Our Ref: TR/I0869/mr

2 November, 2020

**RE: PARRAMATTA WESTFIELD SHOPPING CENTRE
S75W APPLICATION – RESPONSE TO TRAFFIC MATTERS**

ATTACHMENT A

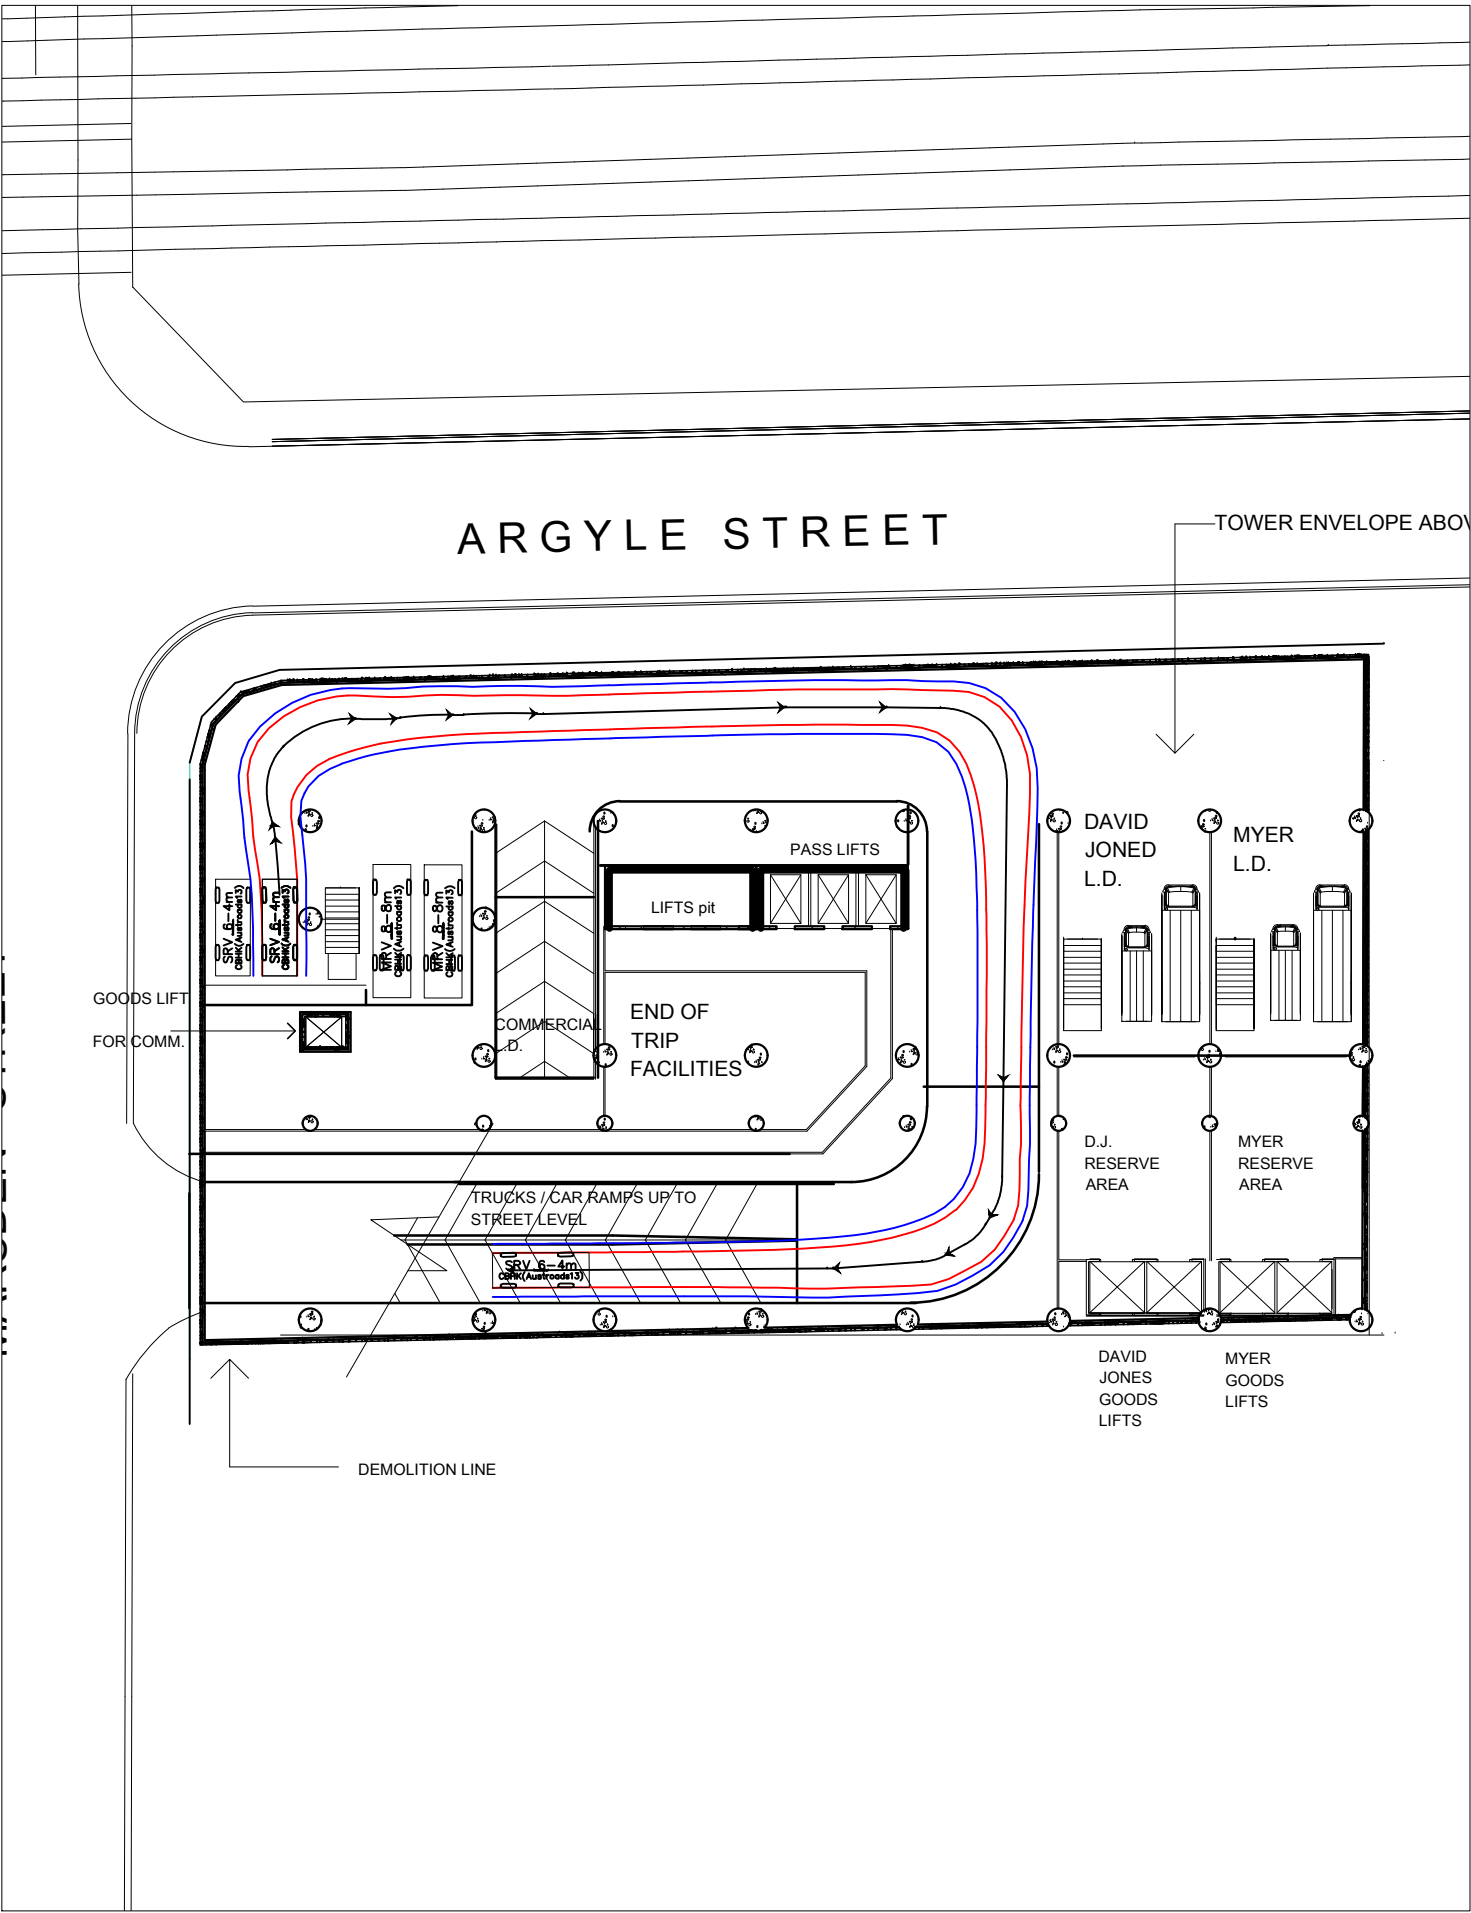
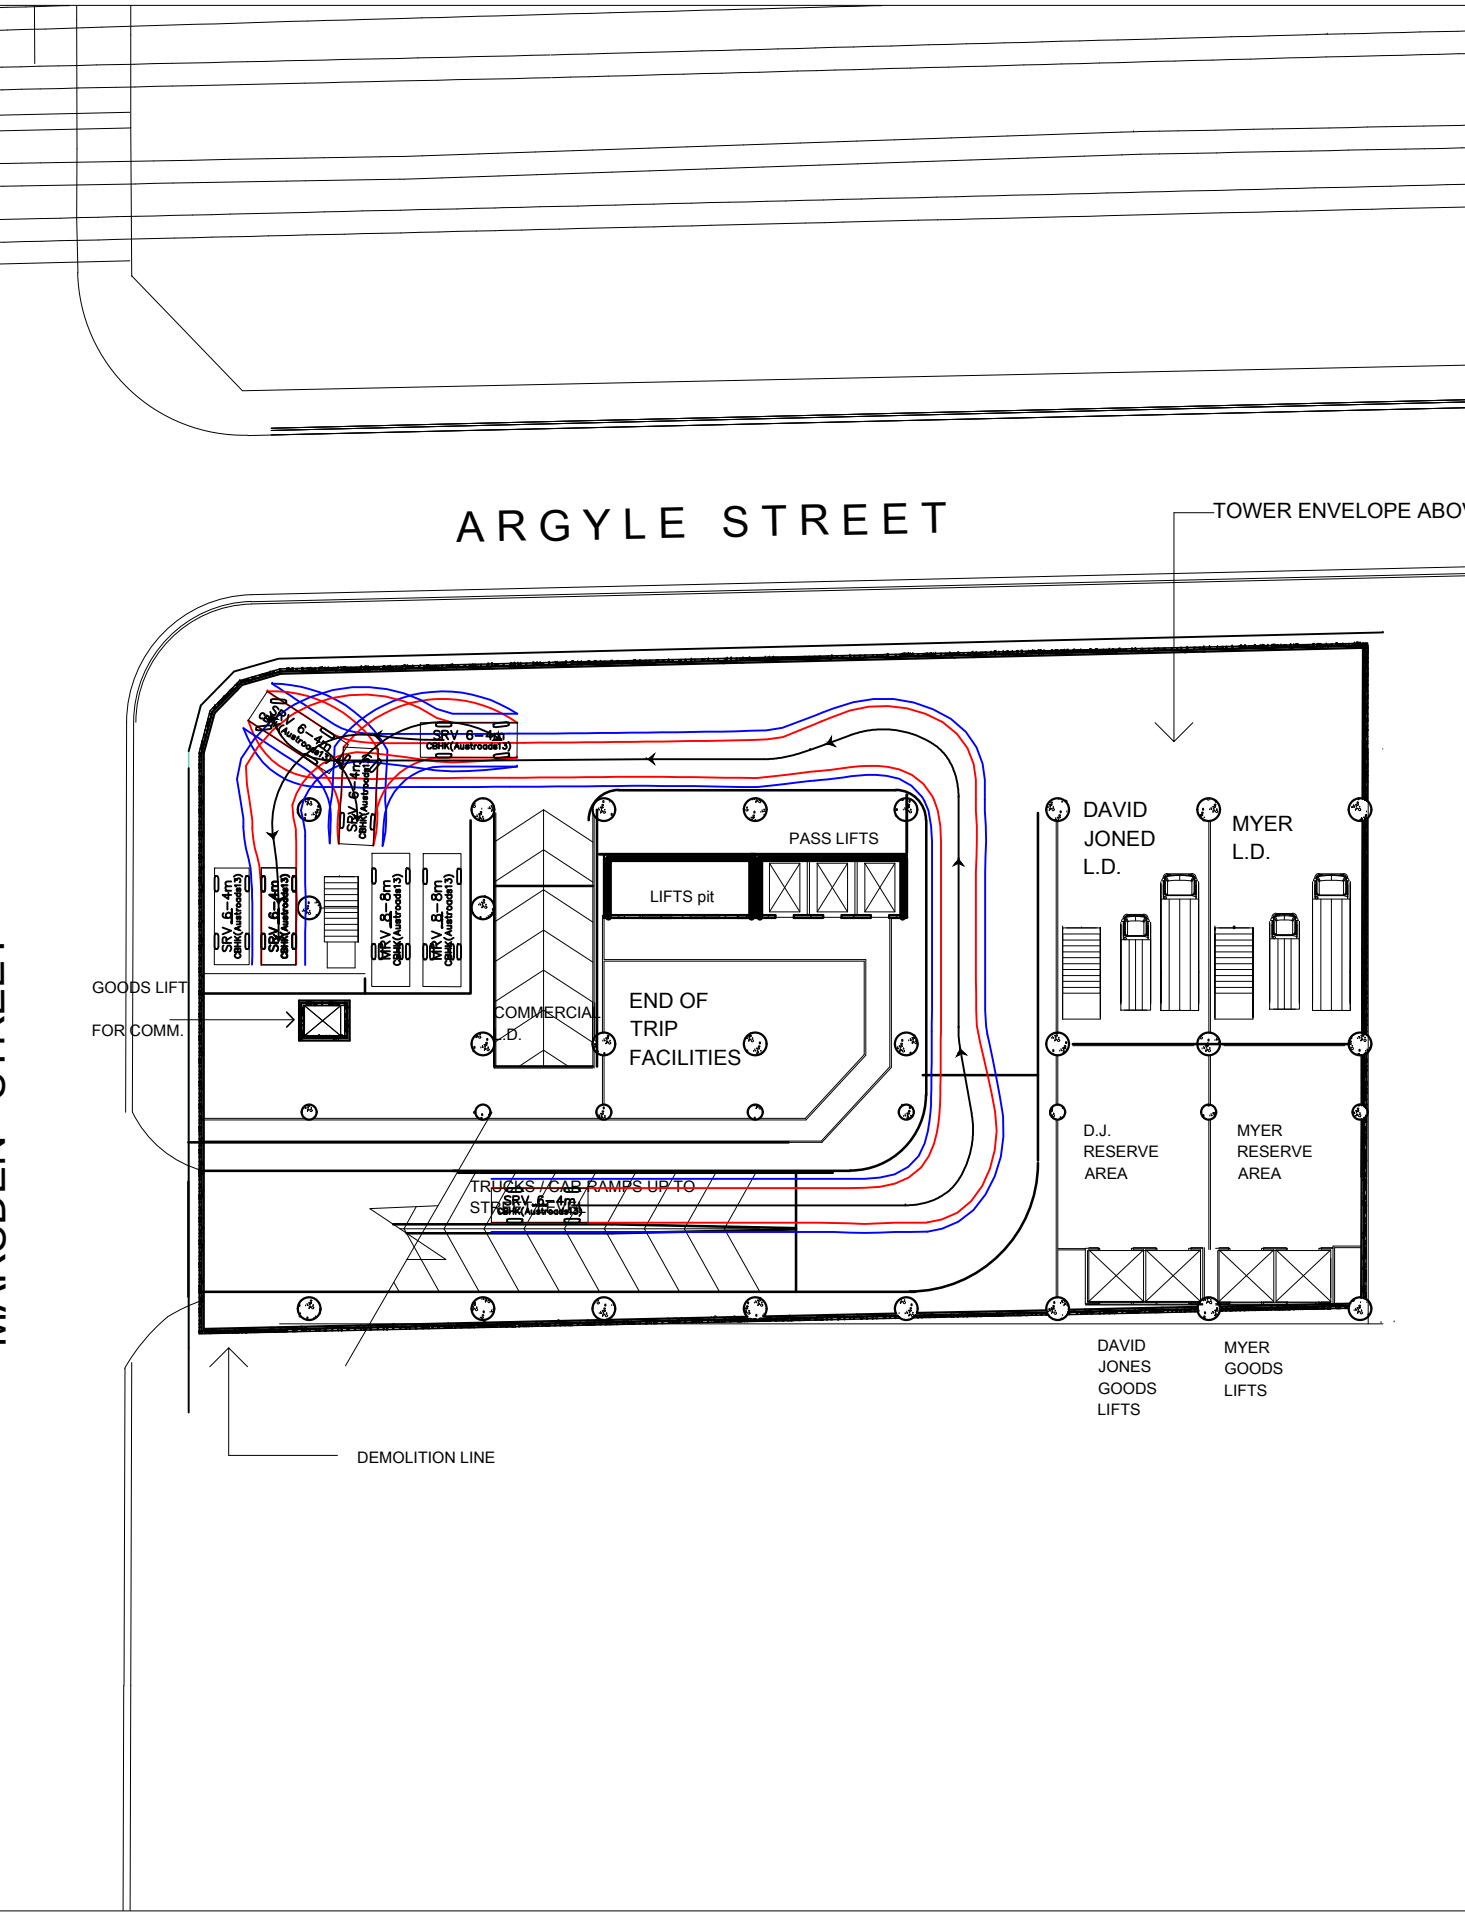
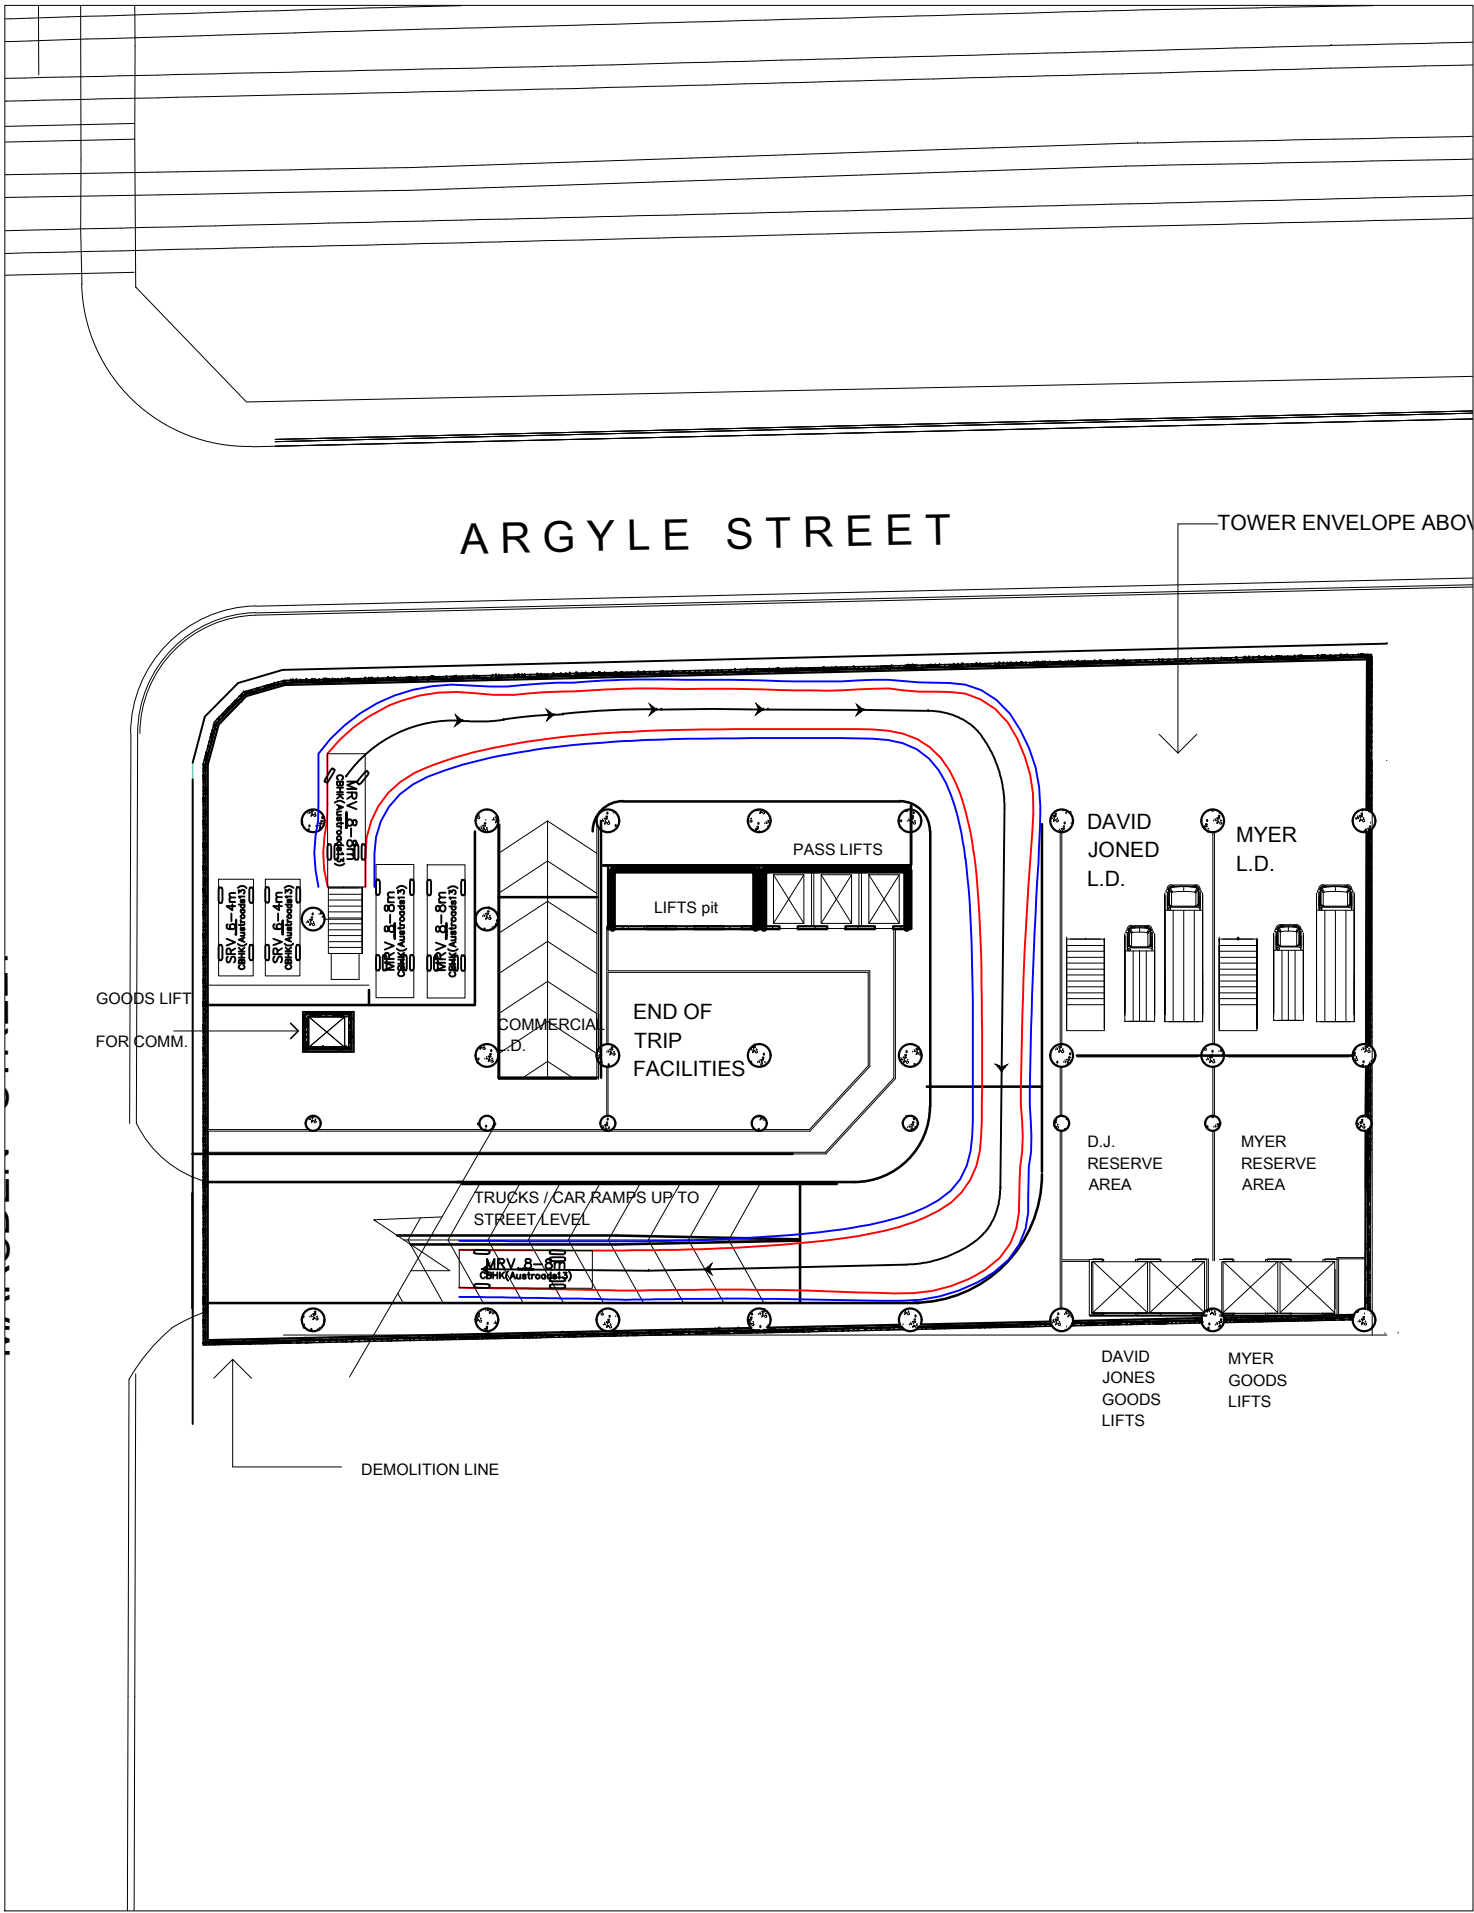
17. TfNSW has requested additional information with regards to the number of service vehicle movements associated with the S75W application, their impact on the surrounding road network and the capacity of the exiting dock to accommodate the additional deliveries for the office tower.

19. Indicative plans of the proposed loading dock are shown in Attachment A with truck turning paths. These show:
- access from Marsden Street (limited to left in/left out by the existing median;

- four loading bays for the office tower;
 - two loading bays each for David Jones and Myer;
 - largest truck that would access the dock being a 8.8 metre rigid truck; and

- all vehicles entering and departing the dock in a forward direction.
20. With regards to the capacity of the existing dock to accommodate the additional demand, as part of a future DA for the relocated office tower, a loading dock management plan would be prepared addressing the matters raised by TfNSW. This would allow further work to be undertaken as part of the DA to address the minor design changes required to the design of the loading dock (as shown on the attached truck swept paths).
